Flood Map Update

MR021 Avoca

PROJECT	Flood Map Update – MR021 Avoca
PROJECT NO.	MR021
PROJECT ENGINEER	Kevin Macken / Daniel Walsh
DOCUMENT TITLE	MR021 Avoca Report

Figure 1: The modelled watercourse alignment (red) and the actual watercourse alignment (green) in Avoca, Co. Wicklow.

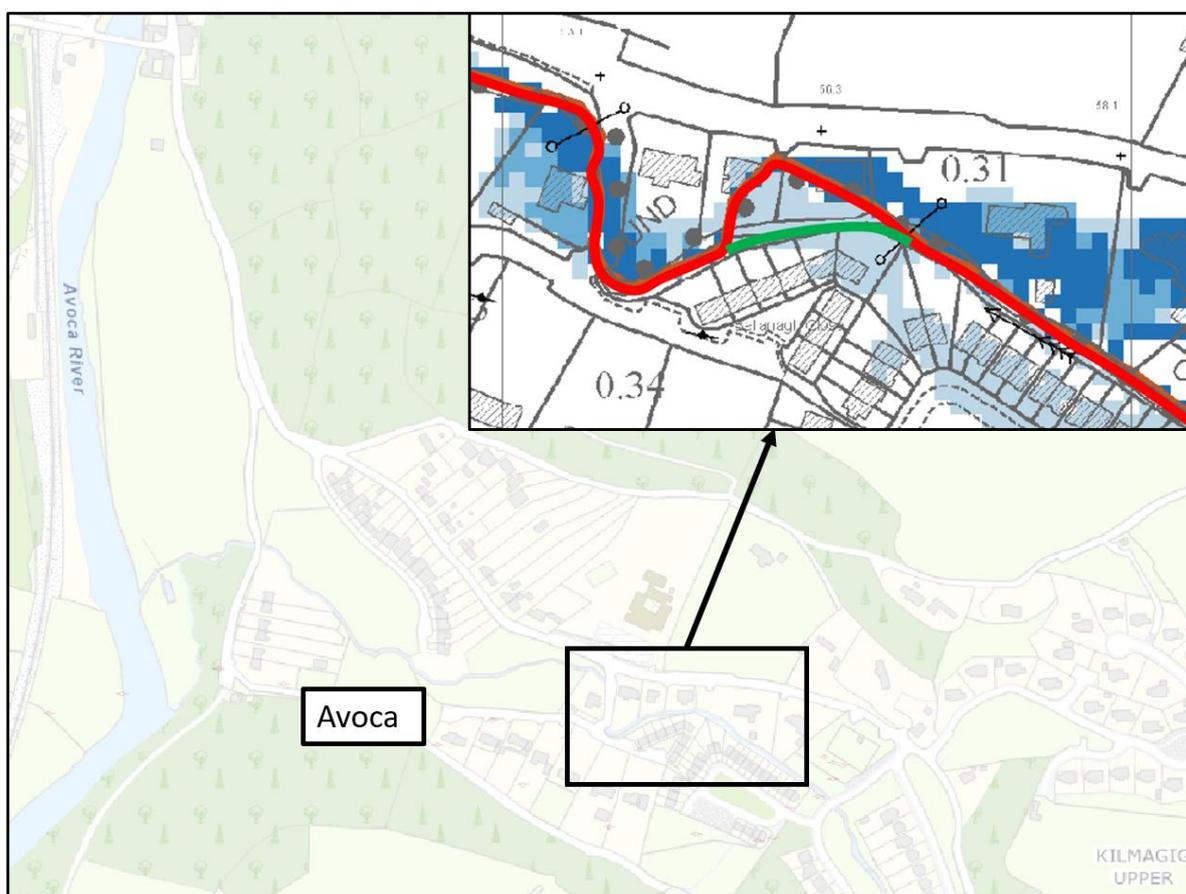
A Flood Map Review Request was received by the OPW which indicated a potential anomaly in the flood mapping regarding the alignment of the Avoca Trib3 watercourse. Figure 1 shows the location of the misaligned watercourse. As shown, this tributary of the Avoca River is modelled (red) as passing through the footprint of two houses rather than along the actual alignment of the river (green).

The Flood Map Review Request also queried the overland flood route that results in the same houses shown to be at risk, noting it was unlikely to occur in reality given the ground levels and streetscape features present.

An initial assessment was carried out of the items raised in the request. It was determined that the alignment of the Avoca Trib3 was incorrectly represented in the model. The tributary passes through the footprint of two houses rather than along the actual alignment of the

watercourse. The survey data for the CFRAM study contained the misalignment, which in turn was used to inform the hydraulic model.

The OPW will only carry out a Map Update when the information provided supports one of the criteria described in Section 1. The channel misalignment identified satisfies the criteria of a survey error. An update of the flood maps is warranted in this case.

Figure 2: Site visit issues identified

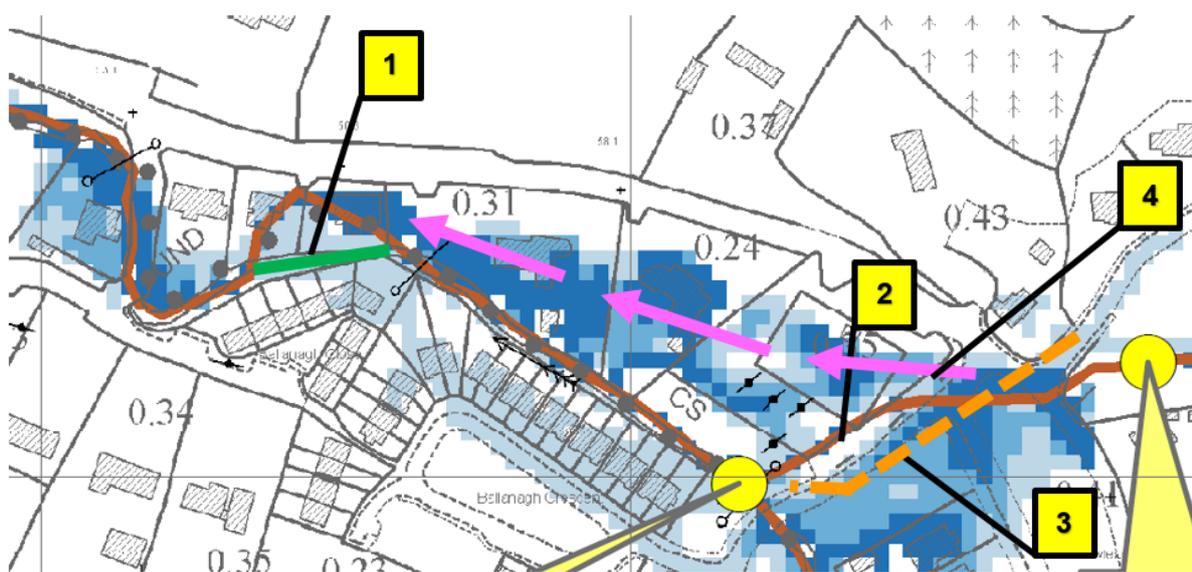
1. The alignment of the Avoca Trib3 was incorrectly recorded in the survey data and therefore incorrectly modelled in the CFRAM study.
2. The final modelled section of the Avoca Trib4 is culverted in a 450mm pipe from a headwall just upstream of the main road (L2180), to where it discharges into the Avoca Trib3. This culvert was visibly blocked to a significant extent at the upstream face by debris, with limited capacity evident.

3. A new 600mm diameter pipe / culvert (orange) has been installed since completion of the CFRAM study by the Local Authority on Avoca Trib4. This runs from the headwall adjacent to the 450mm inlet, to the Avoca Trib3 at a point upstream of the existing 450mm outlet.

4. After inspection, it was considered possible that the overland flow path illustrated in the Flood Maps (identified by magenta arrows) may not represent the actual flow path, owing to the presence of a raised verge and kerb adjacent to the estate road.

- Correct the alignment of the Avoca Trib3
- Retain the existing 450mm culvert in the model and apply a 100% blockage
- Survey the new 600mm diameter culvert and include it in the hydraulic model
- Capture additional survey data to better represent the overland flow path identified by the Map Review Request and incorporate it into the model
- Utilise the hydrological flows from the original CFRAM study to undertake the hydraulic model runs
- Produce updated Flood Maps and associated data from the hydraulic modelling results

Figure 3: Items surveyed

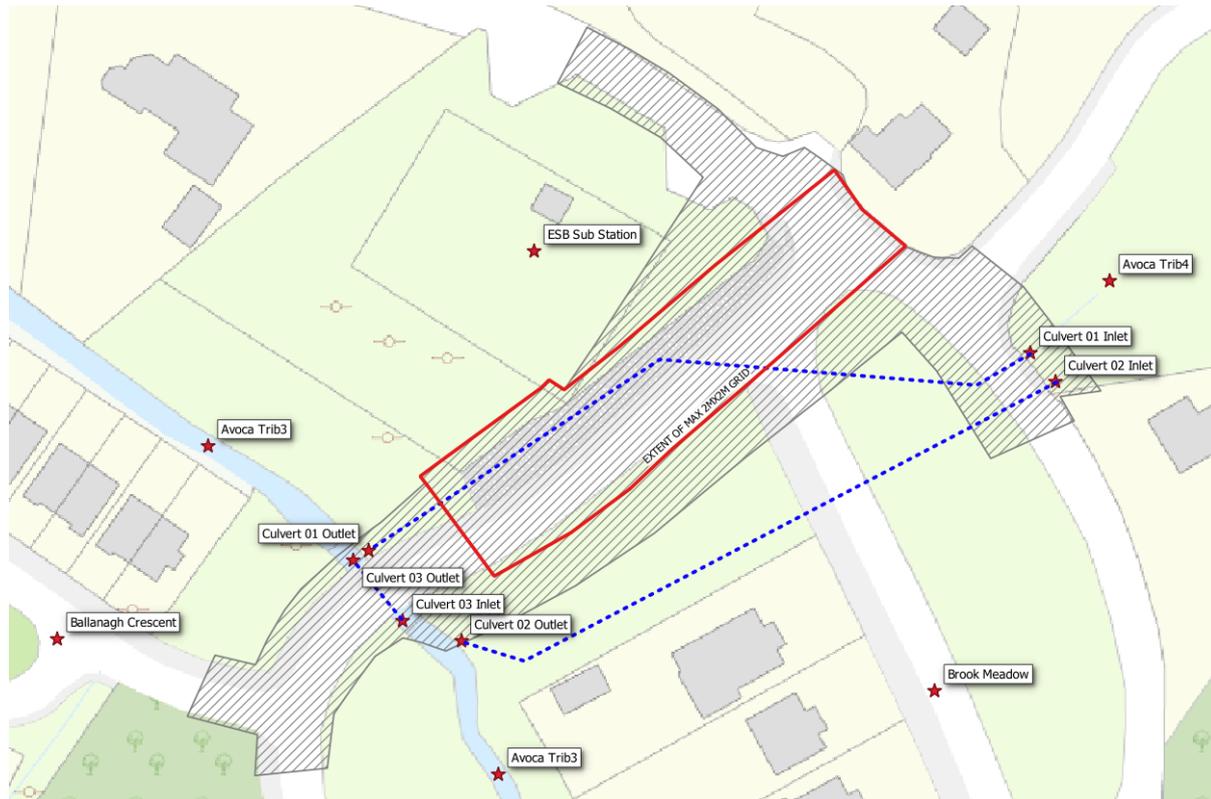
Additional survey data was captured in the areas identified in Figure 3 **Error! Reference source not found.** to improve the accuracy of the mapping. This included:

- A general topographical survey of the area from the upstream end of the new culvert, across the overland flow route (identified by grey cross hatching)
- A detailed topographical survey of the critical area to verify the actual flood path (red outline)
- Invert levels for the upstream and downstream faces of the 450mm Culvert (Culvert 1) and 600mm Culvert (Culvert 2)
- A cross section for the upstream face and headwalls of Culvert 1 and Culvert 2

Figure 4: Comparison of original CFRAM extents and the updated flood extents

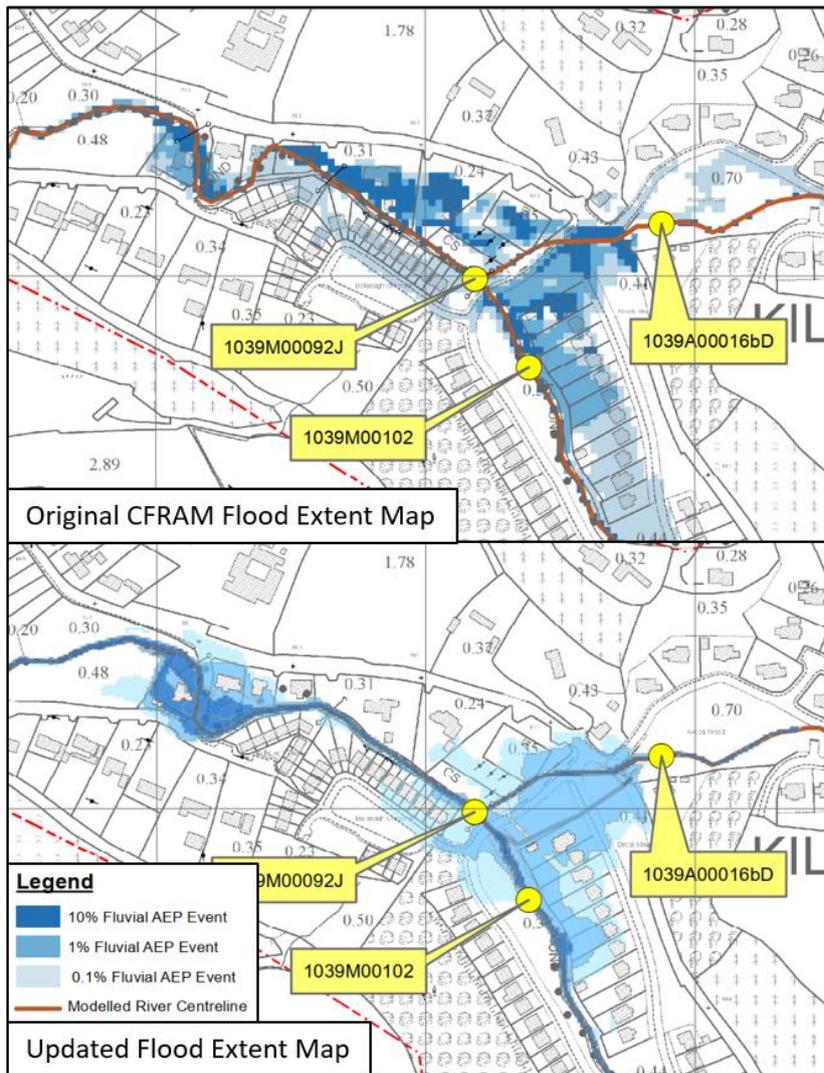
The adjustments to the model have resulted in changes to the flood extents locally, particularly the overland flow route from the culvert inlet across the ESB substation site and several properties to the west (i.e. downstream of node 1039M00092J). **Error! Reference source not found.** shows a comparison between the original CFRAM flood extents and the updated flood extent map.

One of the most notable differences is the decrease in the 10% AEP flood extent across the map update area. The increased resolution of the model relative to the CFRAM Study specification appears to have had the biggest impact on the mapping, producing cleaner flood extents when compared to the original flood maps.
